room2 Homotel: Manchester Piccadilly

Design and Access Statement Addendum (Updated) – July 2024

Document Title	HMP-BA-XX-XX-TRP-A-0004 - Design and Access Statement Addendum (Updated)
Company	Bennetts Associates
Revision	P04
Date	9 th July 2024
Details	Design And Access Statement Addendum updated to address Case Officer comments issued on 13 th June 2024.
Document Number	HMP-BA-XX-XX-TRP-A-0004
Address	Bennetts Associates 38-42 Mosley Street Manchester M2 3AZ

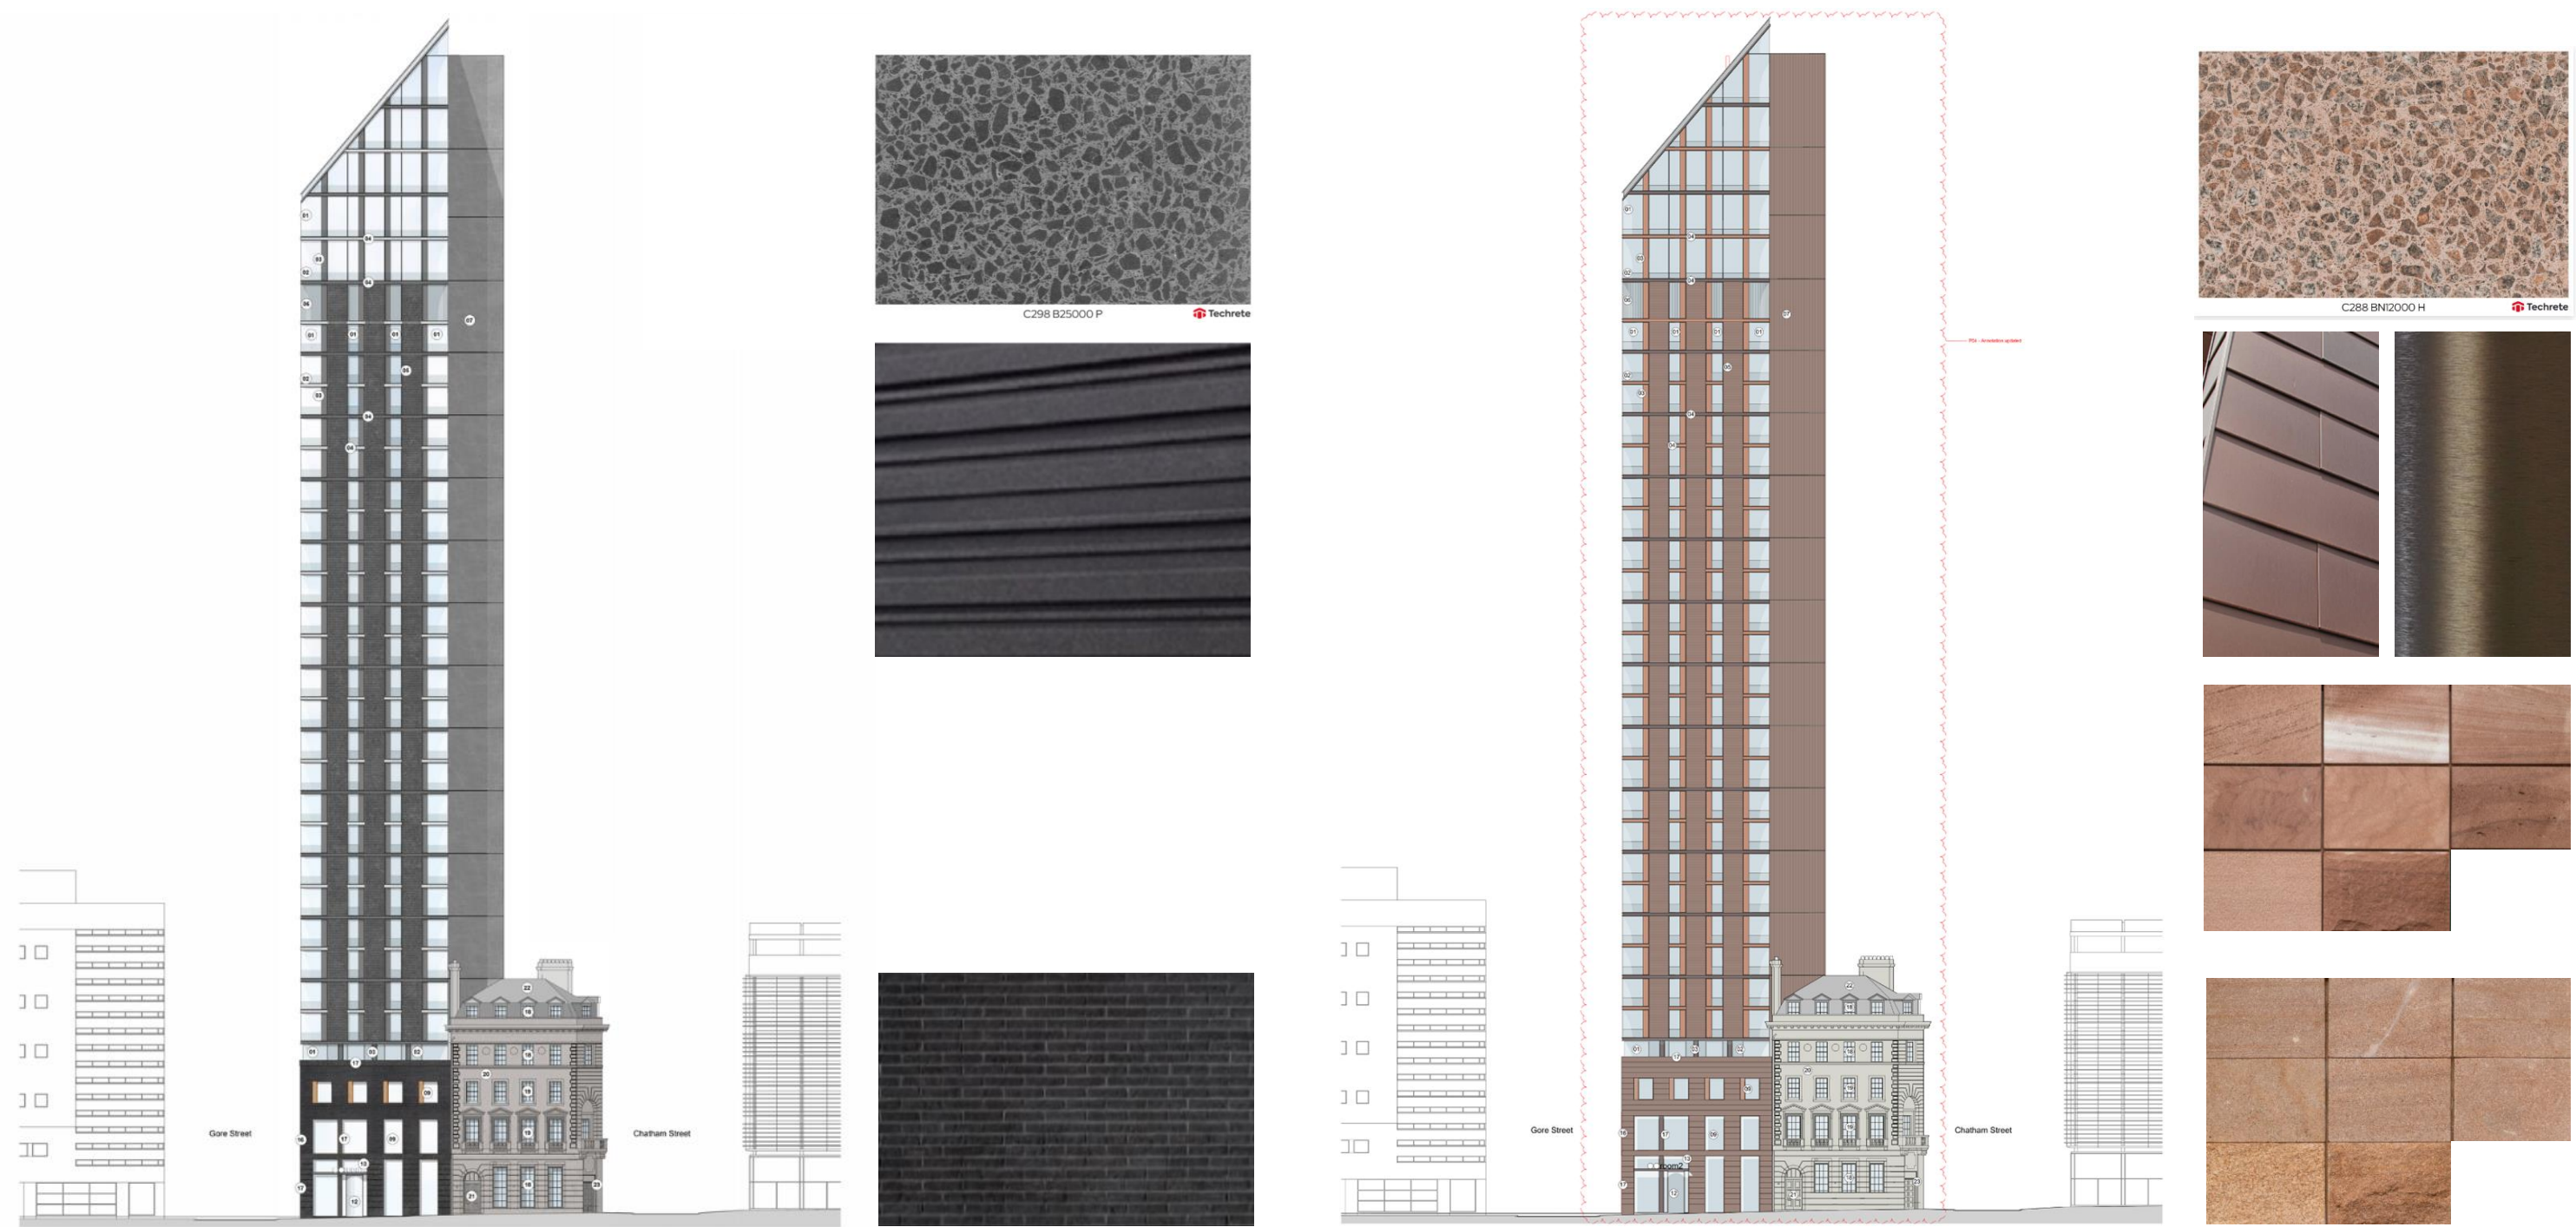
Original MCC Comments: Concerned about the tonality of the materials which appear very grey in some images and would like to see alternatives to this such as more bronze tones which (the submitted drawings also show 12-14 Piccadilly as a grey toned building which is not accurate and this needs to be amended).

Response / agreement at site meeting on 02.04.24: We have investigated the impact of using an alternative warmer tone for the precast concrete and indicated this on the attached views. The warmer (red / brown / bronze) coloured options for the tower colour and base were preferred following discussion. A further request from MCC was received on 19.04.24 stating that “the light grey PPC aluminium side panels will need to be anodised aluminium, in line with MCC’s requirements for other recently approved major city centre developments.” The application drawings will be updated to reflect these changes with samples of material options under consideration, to be noted in the addendum document.

Proposed: East Elevation with updated tonality and materials to address MCC comments. Material options under consideration include red / brown reconstituted stone (precast) or local stone masonry and bronze anodised aluminium to the vertical side panels. Samples of these are included above.

Version of submitted view with grey precast and metalwork to tower

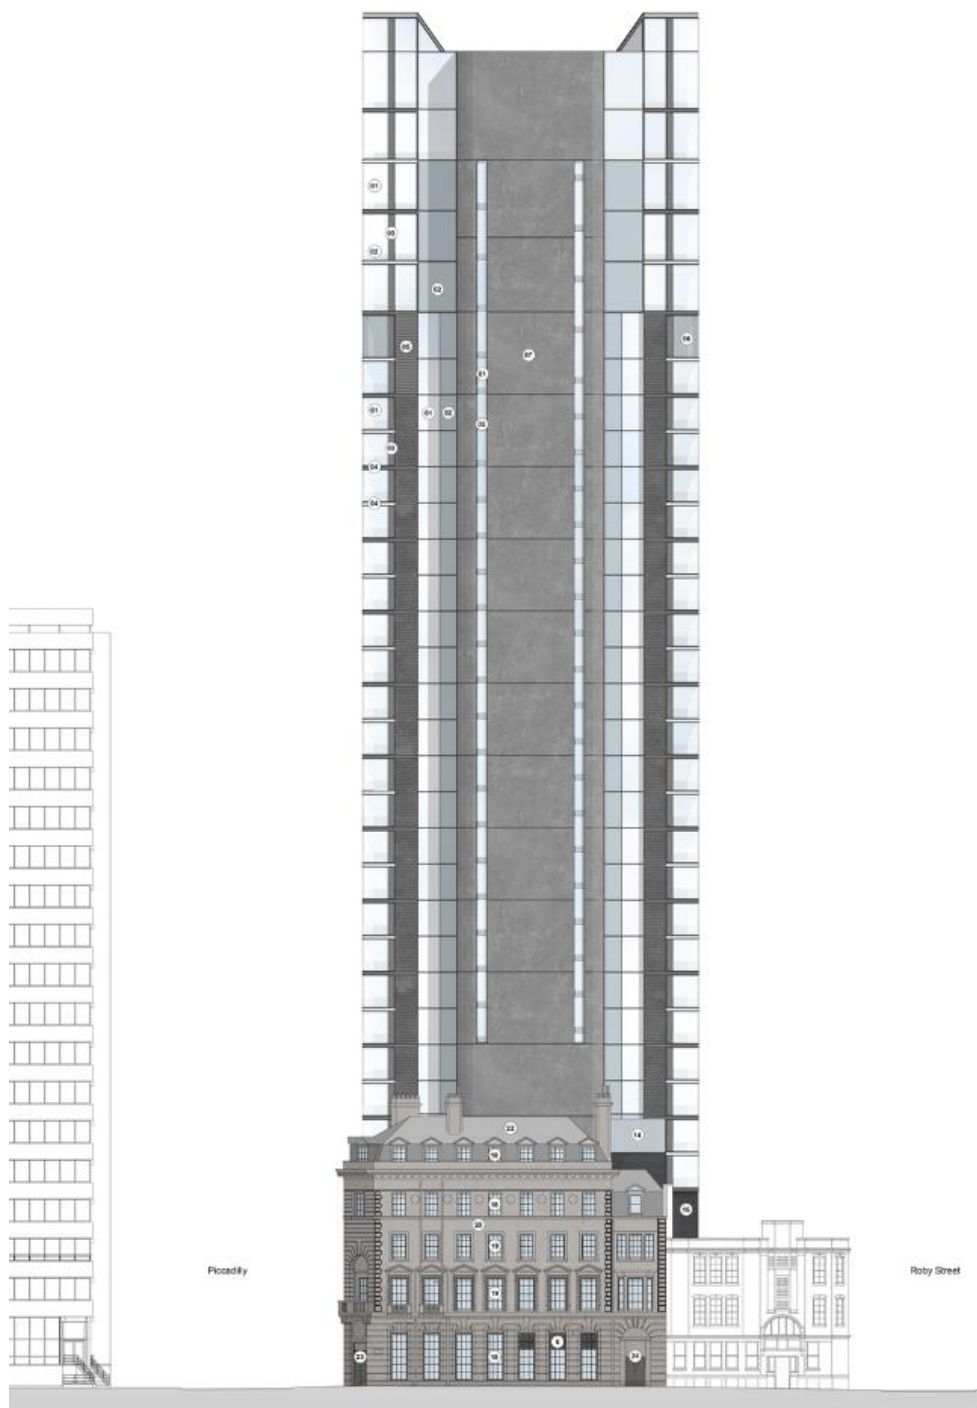
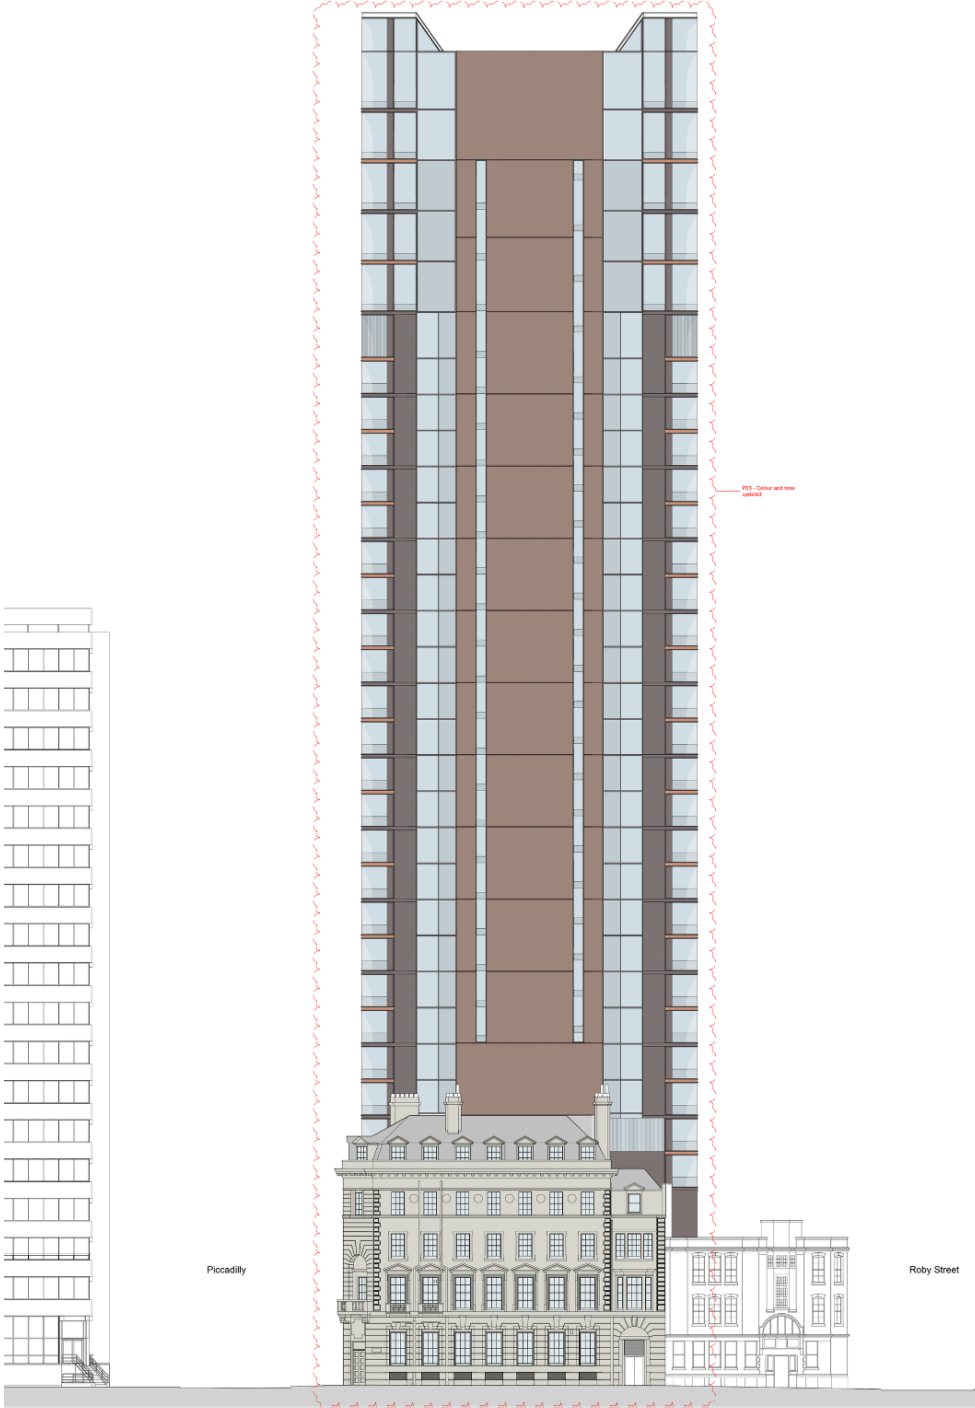
Original MCC Comments: We are not convinced about the use of a dark brick or indeed a brick at the lower levels of the new build element and feel that alternative materials should again be considered here.

Response / agreement at site meeting on 02.04.24: We have investigated replacing the brick with an all-precast solution for the base with wide joints reflecting the rustication of the bank building. This creates the effect of a heavily textured base to the tower element of the scheme. A fully rusticated base in masonry to match that of the former Union Bank was preferred. The application drawings will be updated to reflect these changes.

Amended view with alternative precast and metalwork to tower and rusticated precast of local stone base.

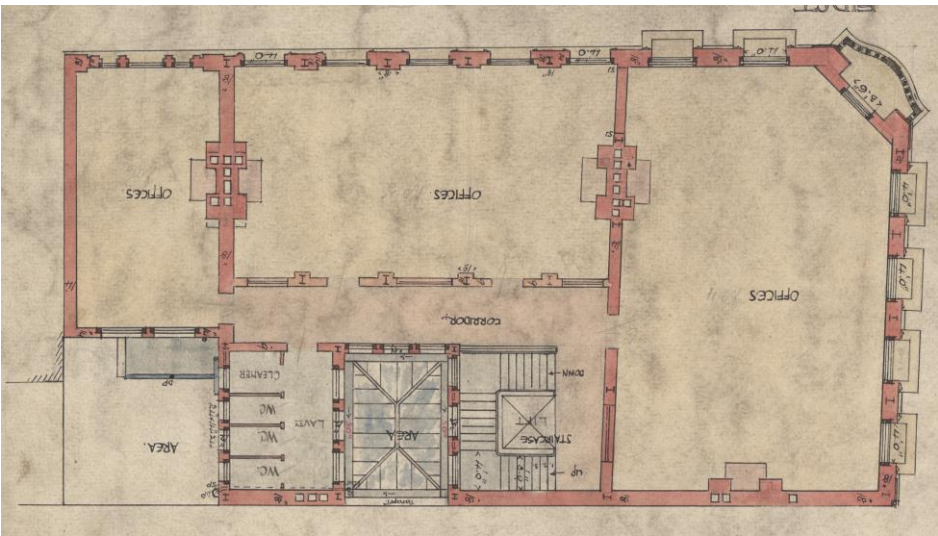
Original MCC Comment: Concerns about the extent of the dark concrete / reconstituted stone panels and the visual impact of this particularly in views from Piccadilly Gardens where this would present a monolithic quality accentuated by the increase in height from the previous proposals. Can alternatives to this which would lighten the appearance or have a less monolithic quality be considered.

Response / agreement at site meeting on 02.04.24: We have revised views to show a heavily textured appearance to the core which results in a less monolithic appearance, see the drawings below and the following amended views. The application drawings will be updated to reflect these changes.

Proposed: North Elevation with updated tonality, materials and textured treatment of the core to address MCC comments. Material options under consideration include red / brown reconstituted stone (precast) or local stone masonry and bronze anodised aluminium to the vertical side panels. Samples of these are included above.

Consented demolition– first floor

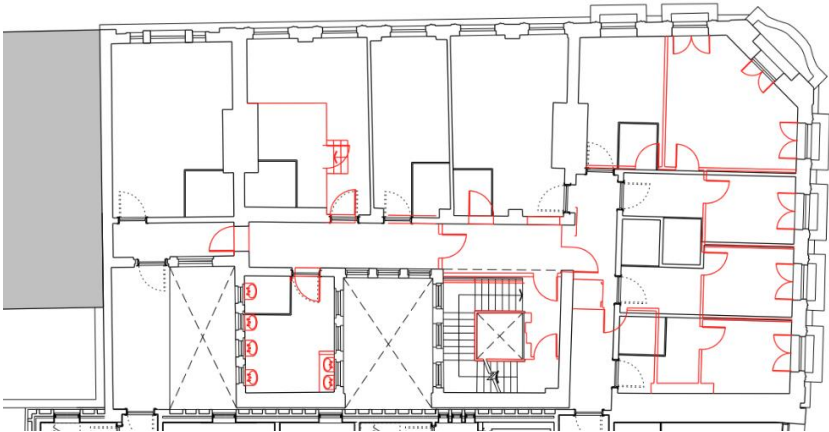
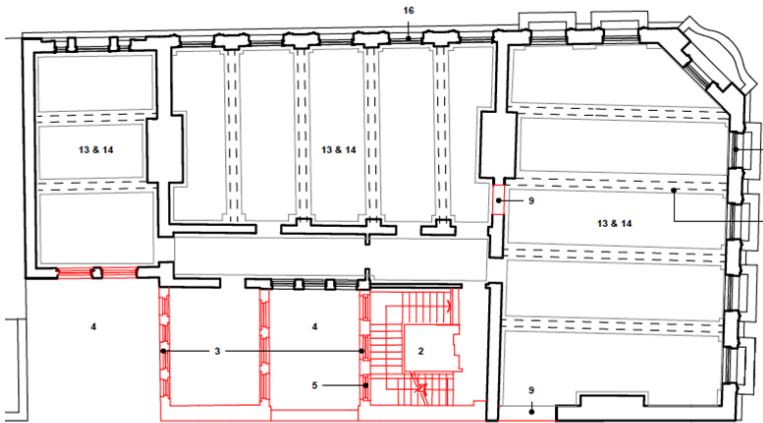
Original MCC Comment: We do not agree with the conclusion of the submitted Heritage Assessment that the overall harm would be minor adverse and our view is that it is at least moderate adverse. There are other areas of intervention that would also cause harm that, with the interventions required for the core would result in that moderate harm and we want to work through some areas of concern with you to reduce that harm and increase the heritage benefits of the scheme.

Response / agreement at site meeting on 02.04.24: The interventions required to create the scheme, including the proposed demolition of part of the listed building were discussed with reference to the plans below. The proposals were generally accepted but further details were requested on aspects of the retained listed fabric. These were summarised following the meeting (see list below). Our responses are covered in the subsequent sections of this addendum, the application drawings will be updated to reflect these changes.

Key Plan noting current position (green) and proposed relocation (blue)

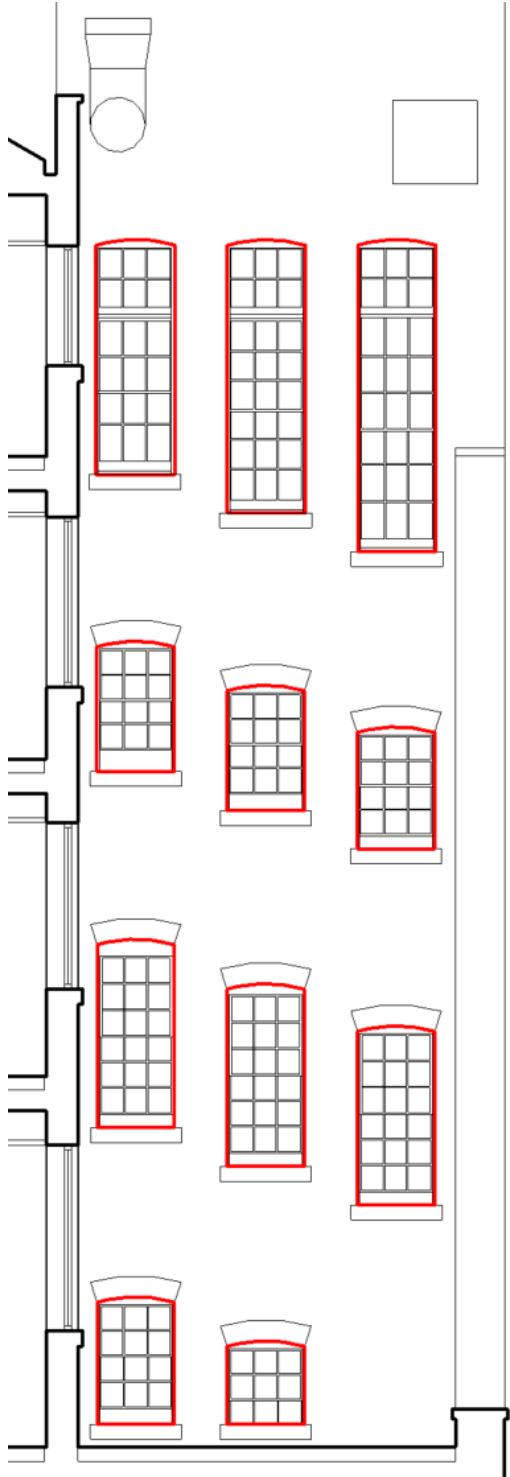
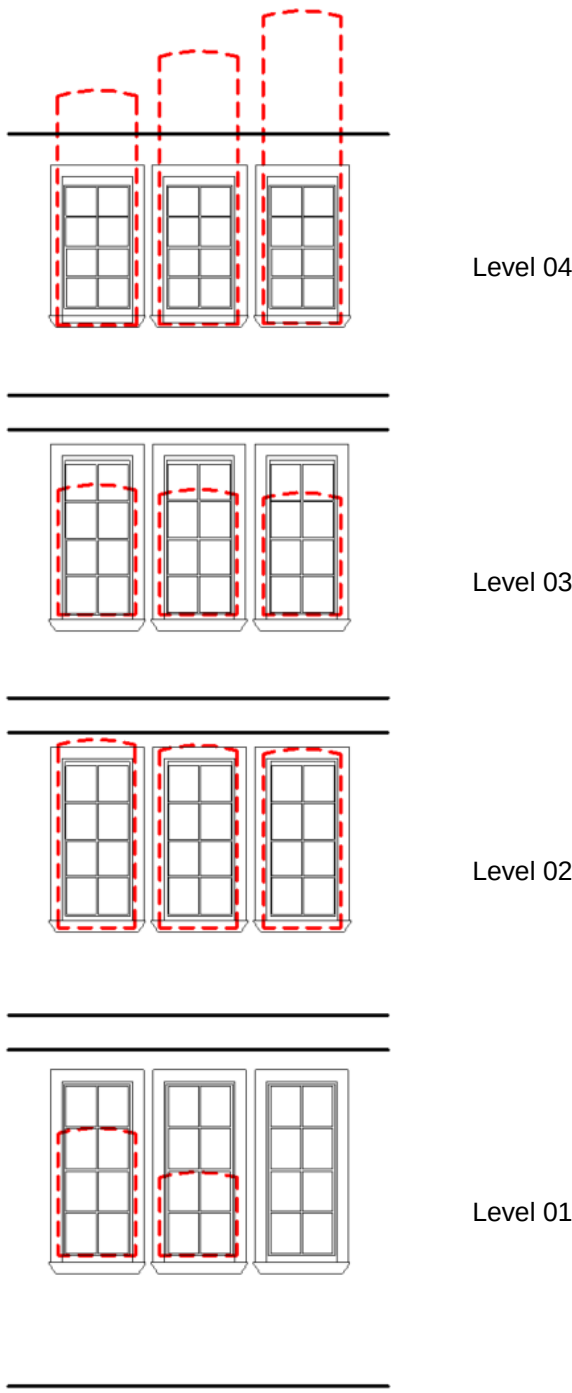
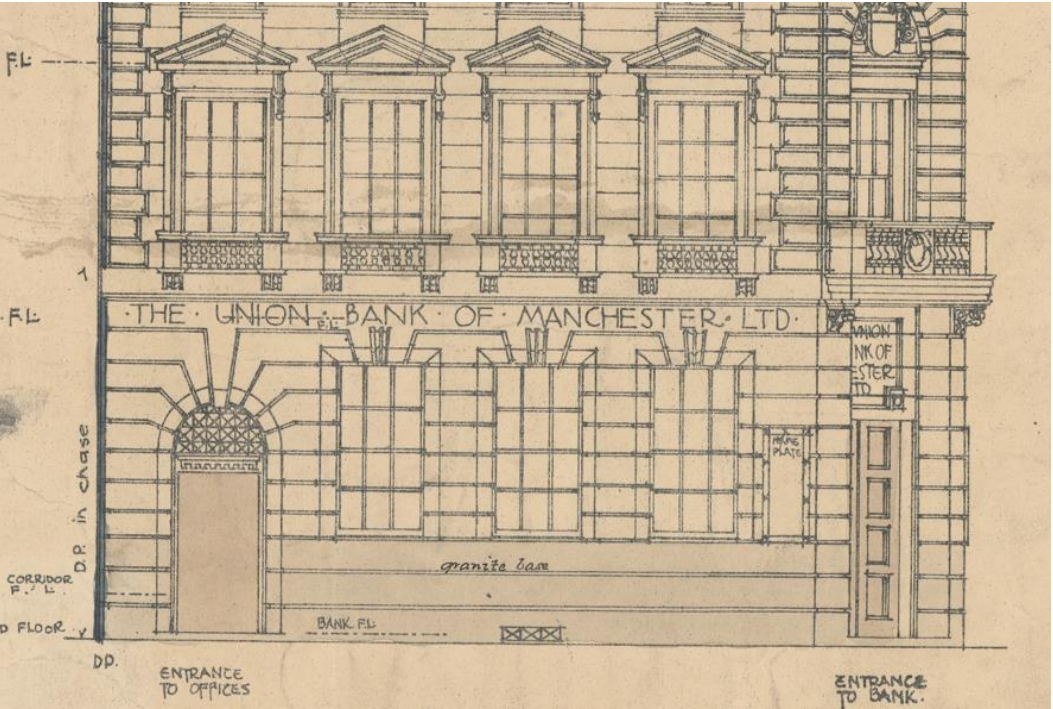
Original MCC Comment: We would want to understand how and where the stained-glass windows are to be retained and reused.

Response / agreement at site meeting on 02.04.24: Proposals will be made to re-use the existing panels of stained glass in the interiors of the public lower floors of the building.

It is proposed that these windows are relocated to the north façade of the lightwell as outlined in the key plan below. Windows at level 01 will be publicly accessible and those at the levels above will be visible from the circulation space between the hotel rooms.
